# UNITED STATES PATENT AND TRADEMARK OFFICE

10/648,784

**Office Action Summary**

FIG. 35

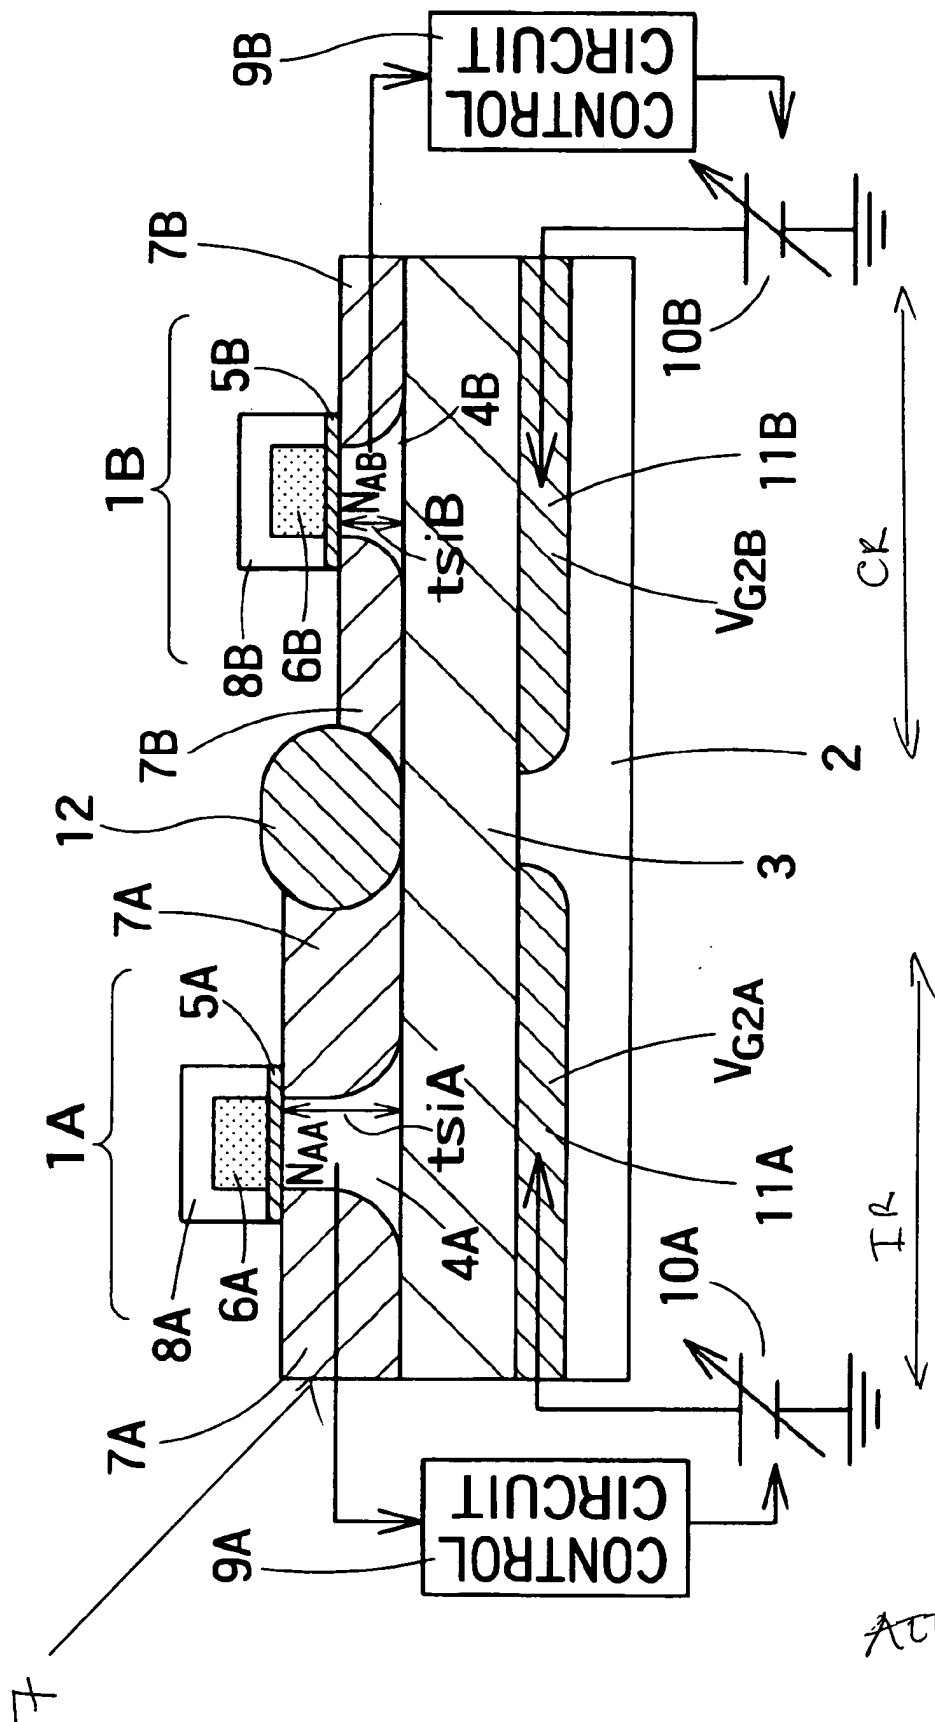
With regard to claim 1, Numata et al. discloses a device comprising an SOI substrate having a SOI layer 7 including a core region (CR) to which a first voltage is applied and an interface region (IR) to which a second voltage is applied; a device separation region 12 for separating the SOI layer 7 into the core region (CR) and the interface region (IR) wherein a thickness of the SOI layer 7 of the core region (CR) is thinner than a thickness of the SOI layer 7 of the interface region (IR), a plurality of first transistors 1B formed in the core region (CR) and in which the SOI layer 7 of the above core region (CR) is a fully depleted Si channel; and a plurality of second transistors 1A formed in the interface region (IR) and in which the SOI layer 7 of the above interface region is a fully depleted Si channel. (Note attachment #1, lines 41,42, column 8; lines 30-33, column 21, fig. 35 of Numata et al.). It is inherent that Numata et al. discloses a second driving voltage of an interface region is higher than the first driving voltage of a core region because the structure of Numata et al. is formed the same as that of applicant, thus the structure of Numata et al. has the same functions as the structure of applicant.

With regard to claim 3, Numata et al. discloses a thickness of the SOI layer 7 of the above core region (CR) is 20 nm. (Note attachment #1, lines 40,41, column 21, fig. 35 of Numata et al.).
